HCSA Rev F release package

The facility taken apart, every flight part drawn and in 3D, the test pieces with their shop drawings and STEP files, what the computer tests found, and what is still open.

For	Marco Cross, fabrication and feasibility review, Tuesday 17 November 2026, 10:00, and Rick Fleeter
From	Manos Theofanous and the HCSA team
Date	13 November 2026
Replaces	The Master Document of 27 October 2026 (Rev E)
Status	Working baseline. Nothing in it is released for manufacture; the test pieces are for quotation

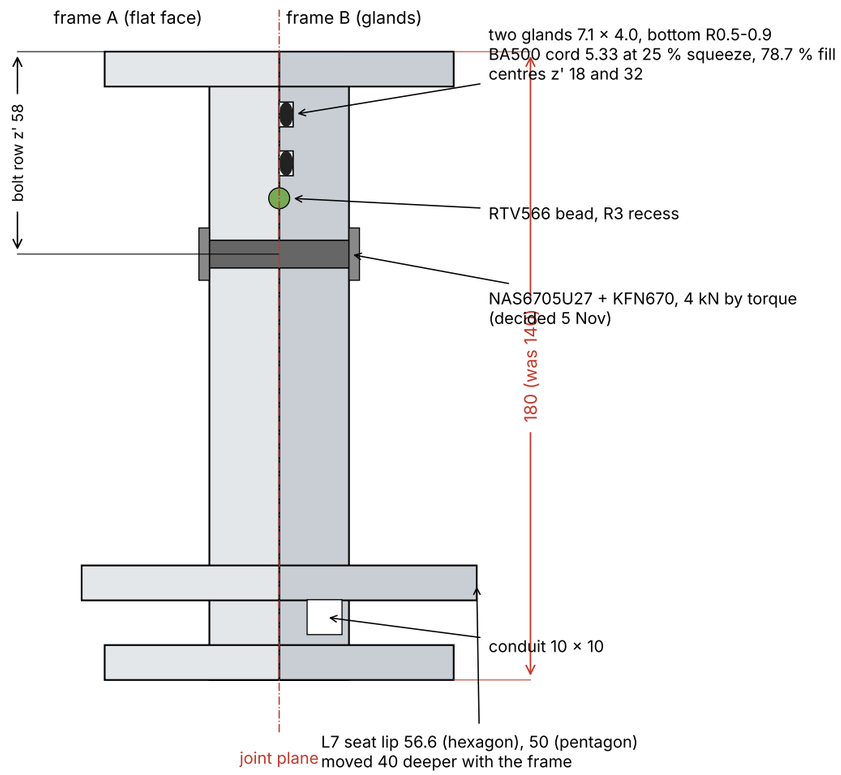
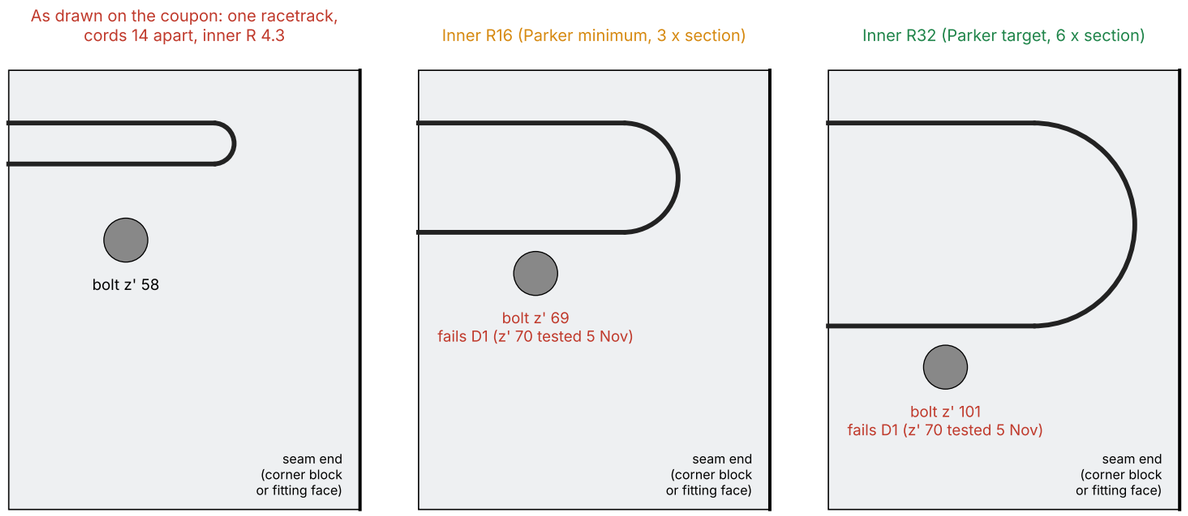
- If each seam's two cords are one racetrack joined at the seam ends, the ends turn at inner R 4.3 mm. That breaks Parker's rule (R16 minimum).
- A racetrack with an inner R16 end needs its legs 37.3 mm apart, which pushes the bolt row from z' 58 to z' 70 or more (z' 102 for R32).
  The D1 run of 5 Nov says no: at z' 70 the seal gap is 0.111 mm at 2.48 kN per bolt, on the 0.11 limit (3.75 kN at z' 58). The bolt row stays at z' 58.
- If each cord is its own closed loop around the whole panel (Rev B intent), the turns are at the vertices, 60 deg on a hexagon, 72 deg on a pentagon,
  through the corner block and the O10 corner seal. That corner needs CAD of the block; it is not checked here.
- Next: draw the loop path through the corner block in Fusion
  (turn the loop round the end bolt, or widen the frame flange locally at the panel corners), after Parker answers 'two loops'.

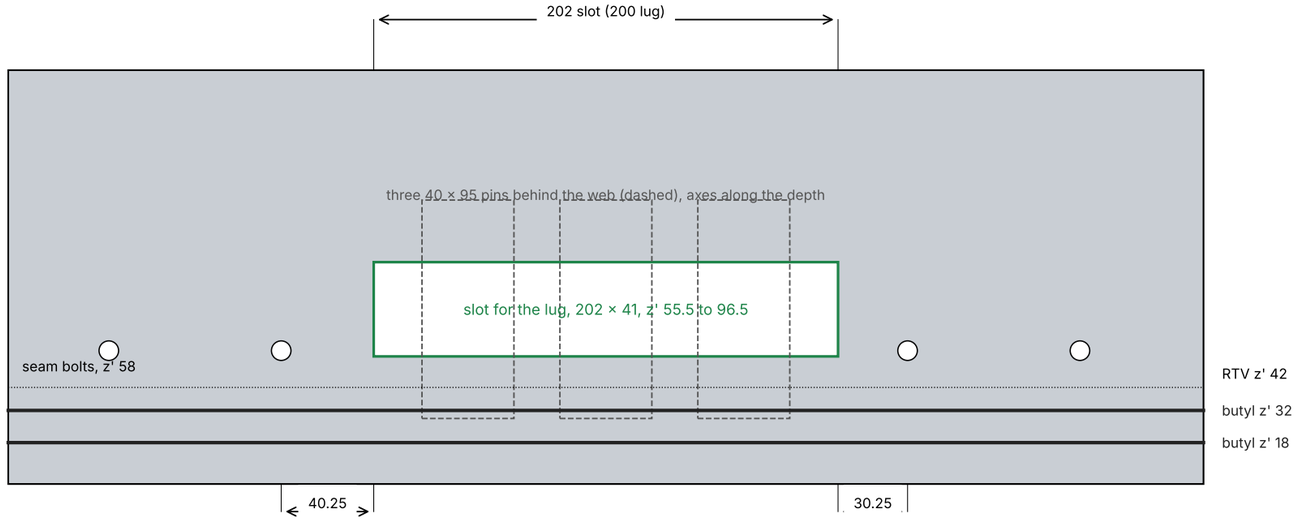
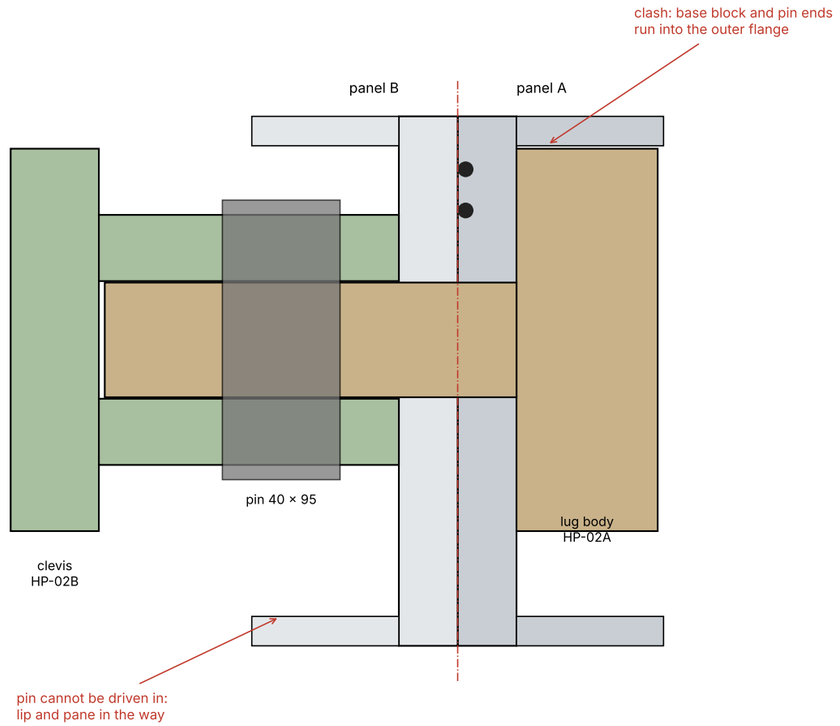
What the fitting is. Measured from the October C3 model (the run that gave 2.876 million N/mm): a Ti-6Al-4V lug 39 thick and 200 wide on panel A reaches across the joint into a clevis of two 22.5 mm cheeks on panel B; three A286 pins, 40 × 95, at 60 pitch, run along the panel depth with no clearance and work in double shear. The 8 November solids (pins across the joint, a pad of 200 × 60) were wrong and are withdrawn.

What the models say (HP1, 6-7 Nov). With the fitting where sheet RE-06-1 put it, 64 mm deeper than the line of the pull, the frames hinge about it and the seal gap reaches 0.11 mm at 0.22 atm (0.47 with the frames held) against the 1.93 atm required. With it on the line of the pull (lug mid-plane at z' 76) the gap at the hardpoint is 0.064 mm at 1.93 atm; the band at the plain bolt beside it reaches 0.11 mm at 1.87 atm, 3 % short. Runs with that bolt closer (115 mm) and tighter (6 kN) are on the laptop, 9 Nov. Those runs model the fitting as a spring between rigid pads of 200 × 60, not this part.

The position of the hardpoint is settled, but the part behind it still has to be redesigned to fit the 180 mm frame (part 2, sheet RF-07).

HCSA RF-08 Corner node: blocks, ties, dowels, what the model says, machining

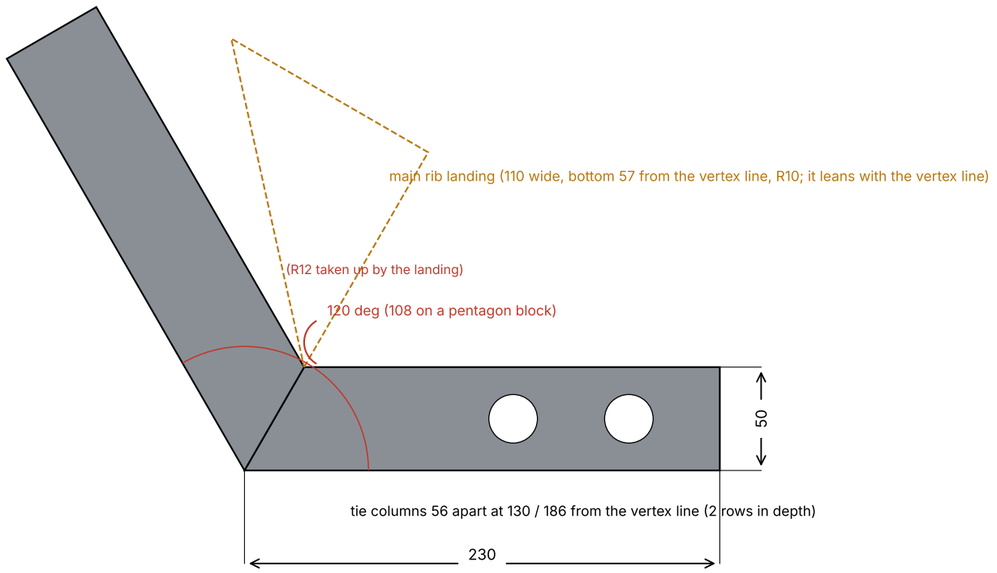
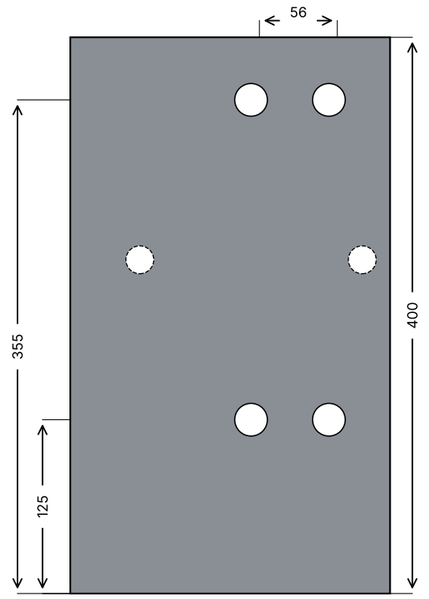
Item	What is open	Who, when	Holds up
Corner node, machinability **(Marco)**	Marco: as drawn it cannot be machined; inside corners need radii an end mill can cut; it could be cast, which may change the material. Also the tie-to-fillet clash (Q29), the O10 corner seal section (Q27), the units on Heintges' 4-6 lap (Q28), and the way the main rib flanges enter the block	Manos with Marco, 17 Nov; Fusion	RE-06-2, T3
Corner block stress limit	95th percentile 236 MPa at proof at 0.8 atm, 255 MPa with the hatch open; no limit has been set	Manos, Rick, Henann	Signing the corner
Corner tie tightening	198 kN by measured stretch. The band of 196.5 to 198.1 kN and the 0.7 kN hatch-open margin are both tighter than any tightening method can hold or any model can promise, so either the preload comes down (runs at 180 and 160 kN restarted 13 Nov) or the hatch-open case is ruled out by the lock. A multi-jackbolt nut would set it with a hand wrench	Manos, with Marco on the method	RF-08, T3

1. The corner block is machined from plate, not cast and not die forged (RF-08, CB-01). It carries seal loops on two faces, and a casting's porosity is a leak path there; there are only 180 blocks, too few for a die. Cut from a billet it starts at 87 kg and ends at 23 kg. Every surface is a plane or an R10 corner parallel to one line, so one set-up on a rotary axis does the faces, the landing and the holes. The R10 corners are 430 mm long and have to be cut from the open side. The weak spots are the 17 to 20 mm of metal between the rib landing and the joint face, and a washer seat 3.4 mm from the landing edge on the pentagon block.

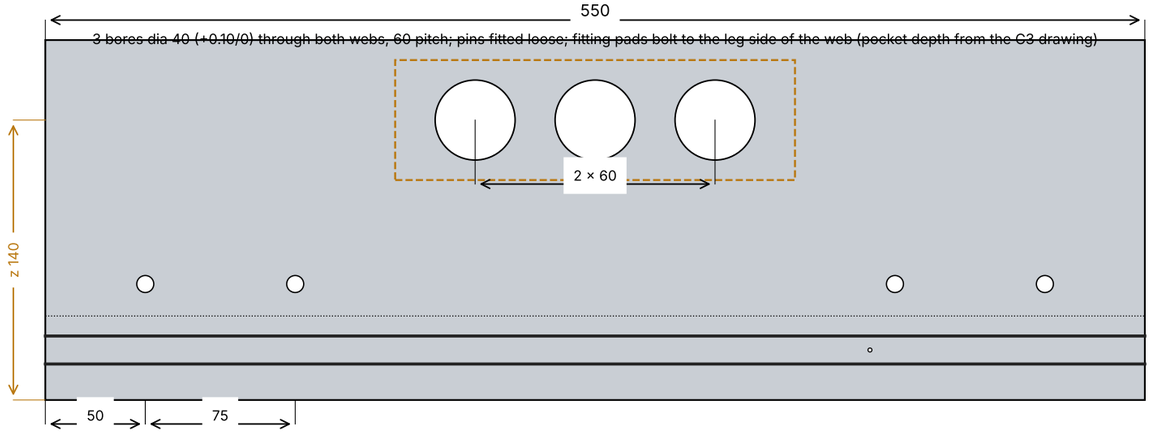
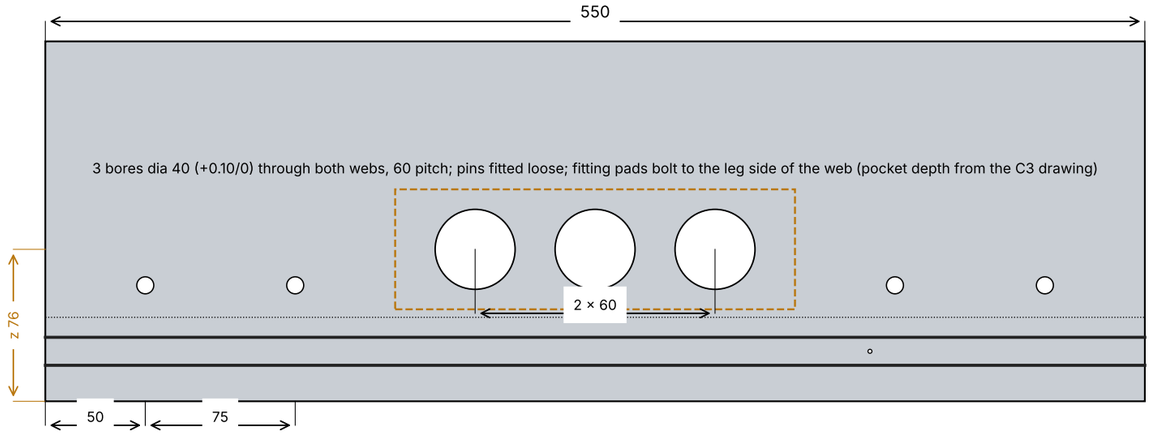
- The hardpoint position, which decides whether we cut SA-550 or SA-550 moved.
- Whether run 1, the straight pull, stays in the plan now that run 2 pulls at the right depth.
- The leak test on the 550 article: the pass rate, and the port and fittings for it.
